ADDENDUM NO. ONE

WATER SYSTEM IMPROVEMENTS

IRON AND MANGANESE FILTERS

PROJECT NO. 192310

Revise Section 7.12.G.1.h.2 on Page 7-8 to read:

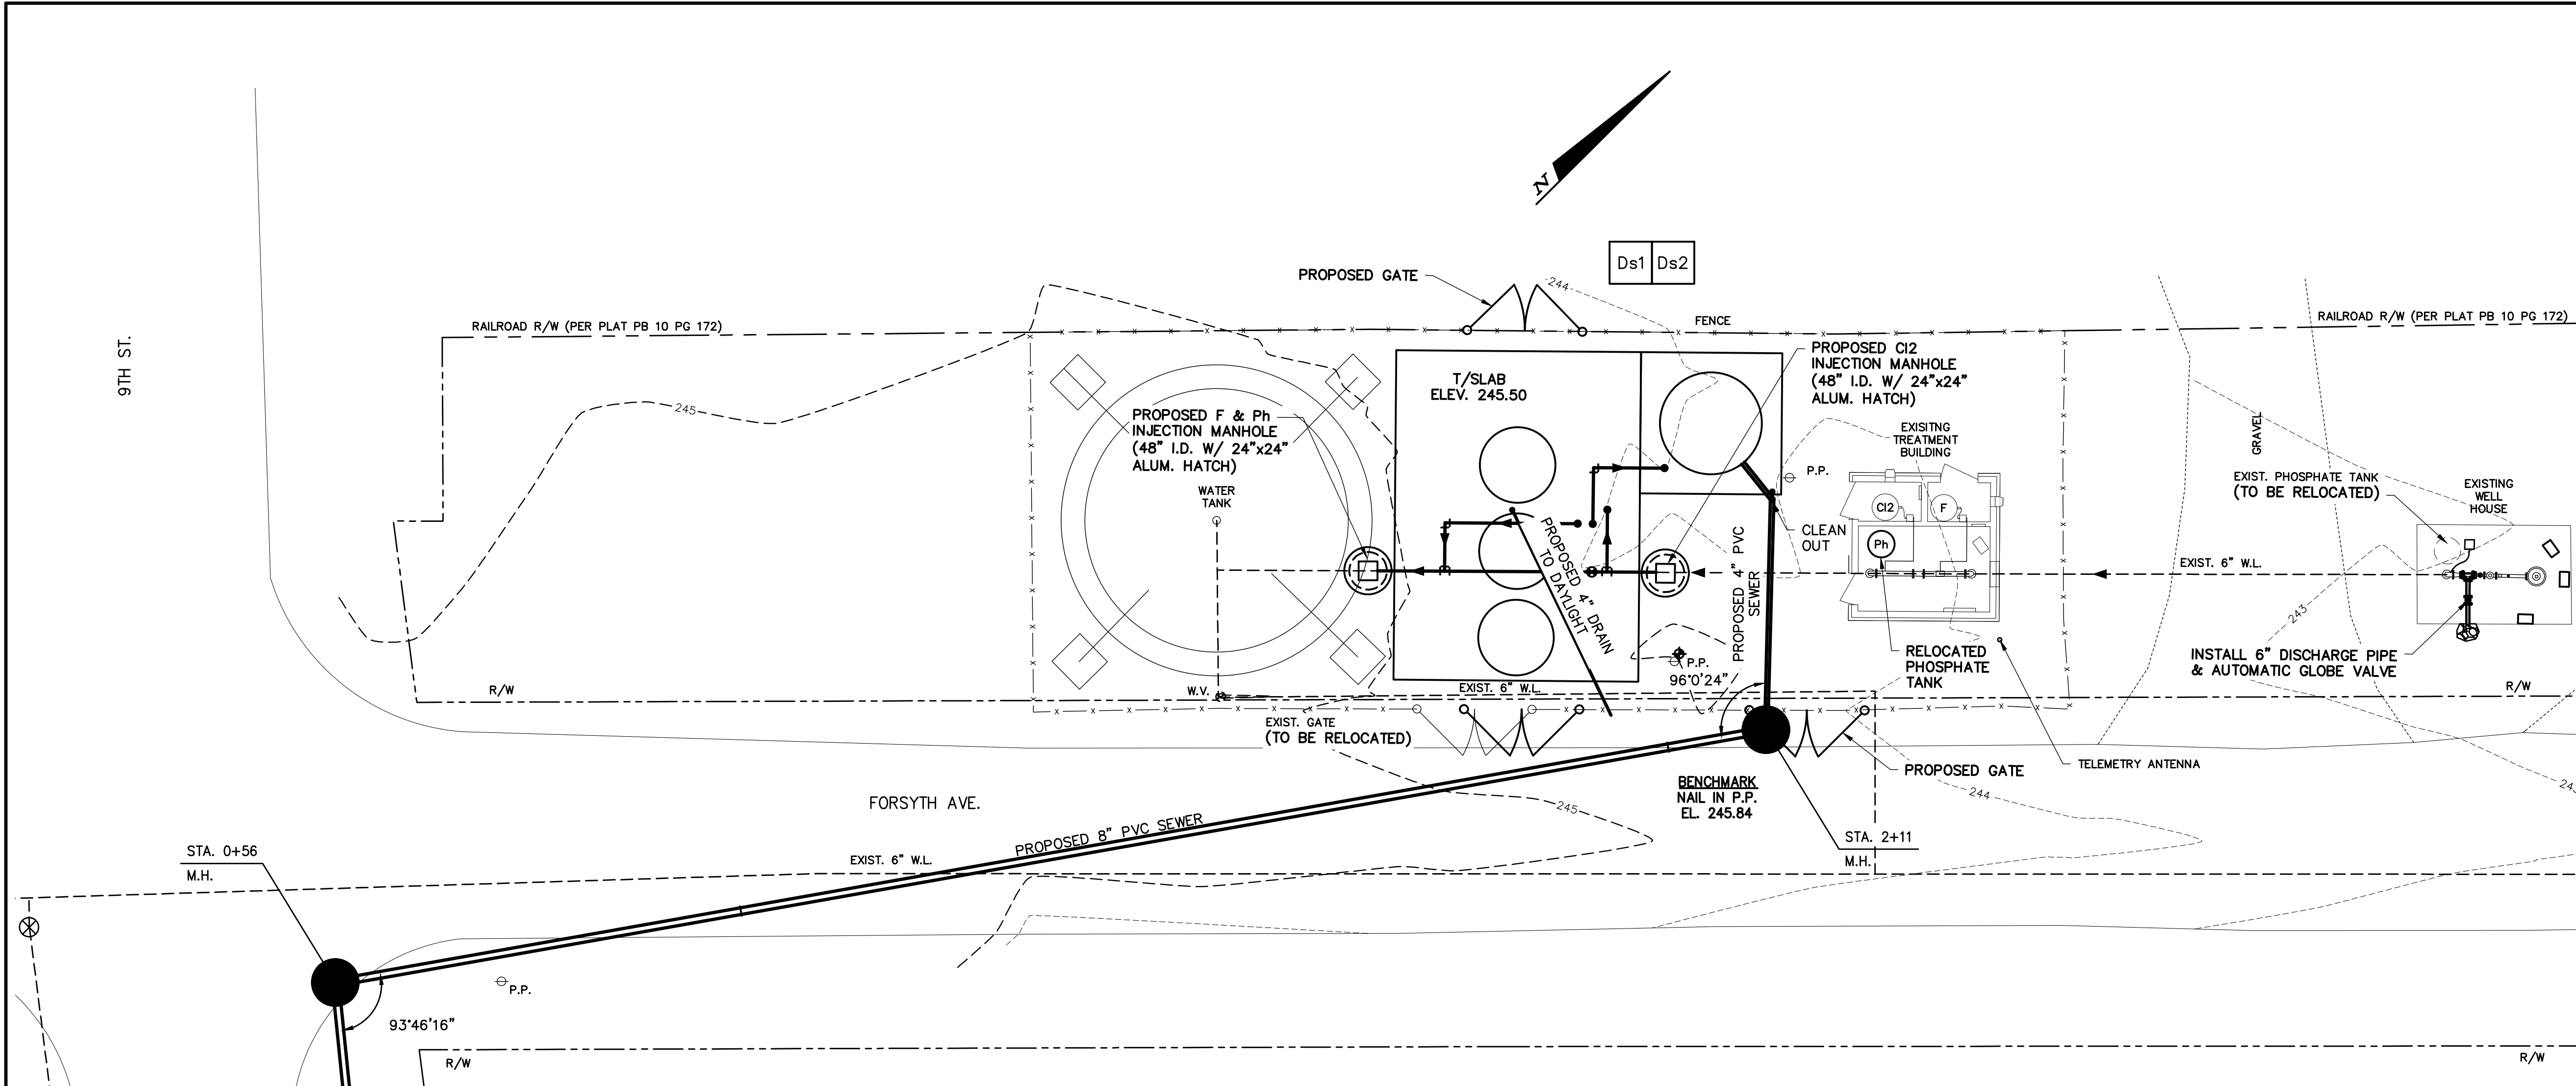
- 2) Outlet Collector:
 - Type: Hub and slotted laterals w/ 0.010" slots
 - Material: **Well #1 – SCH 80 PVC**
Wells #2, #3, and #4 – 304 Stainless Steel
